Access Compliance Report

Public Rights-of-Way

Intersection ID: 32099	Main Street: STEELE_CREEK_RD	Cross Street: ROTHE_HOUSE_RD	Location: SE
ADA ID: 2103D85F69A9	Ramp Type: PerpDiag	Initial Pass/Fail: Pass	Overall Compliance: No
Severity Score: 10			
Codes/Mitigation Info/Possible Solution		Field Measurements/Component Compliance

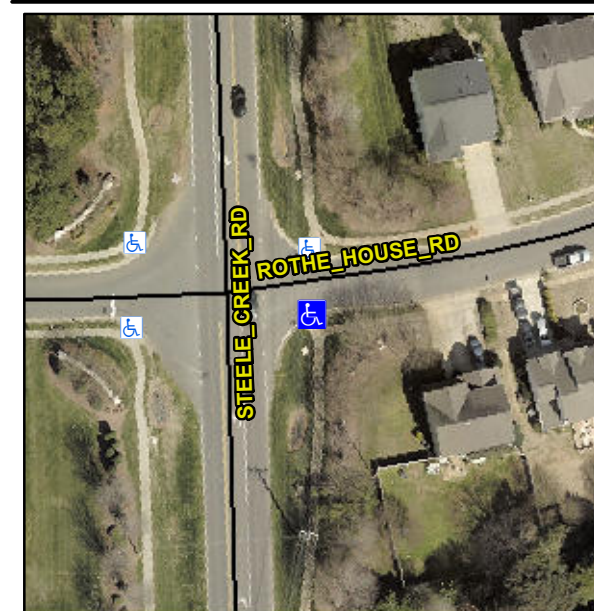
Remove & Replace Curb Ramp With Two New Directional Ramps or Equivalent.

R304.2.2-Perp, R304.3.2-Para, R305
